Evaluation of proposed move for Water Right No. 16776

Proposed: Move water right no. 27620 ID1 a distance of 2,490 ft east to a new location.

Data Set: C:\Users\scanstation\Documents\move requests\16776\16776 current.aqt
Date: 11/27/24   Time: 10:09:11

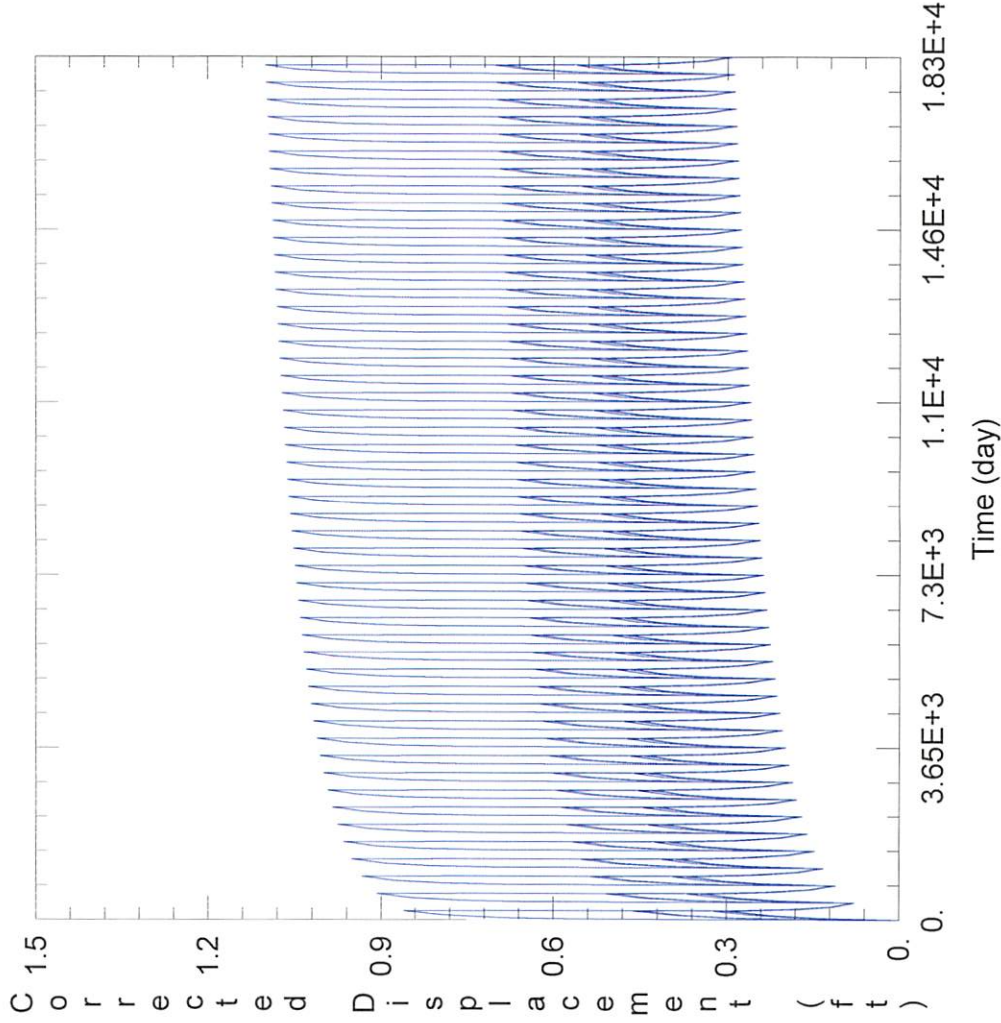
28302:	Drawdown from current location = 0.68 ft
	Drawdown from proposed location = 1.08 ft
	Net drawdown = **0.4 ft**
8846:	Drawdown from current location = 0.54 ft
	Drawdown from proposed location = 1.04 ft
	Net drawdown = **0.5 ft**

3353:   Drawdown from current location = 0.53 ft

Drawdown from proposed location = 1.19 ft

Net drawdown = 0.7

17132:   Drawdown from current location = 0.57 ft

Drawdown from proposed location = 1.43 ft

Net drawdown = 0.9

9440:   Drawdown from current location = 0.70 ft

Drawdown from proposed location = 1.10 ft

Net drawdown = 0.4

Domestic 1:   Drawdown from current location = 1.10 ft

Drawdown from proposed location = 1.60 ft

Net drawdown = 0.5 ft

Domestic 2:   Drawdown from current location = 0.6 ft

Drawdown from proposed location = 1.44 ft

Net drawdown = 0.9 ft

Net drawdown does not exceed the drawdown allowance of 3.0 ft for any well within 1 mile of the proposed location. Therefore, critical well analysis is not necessary.
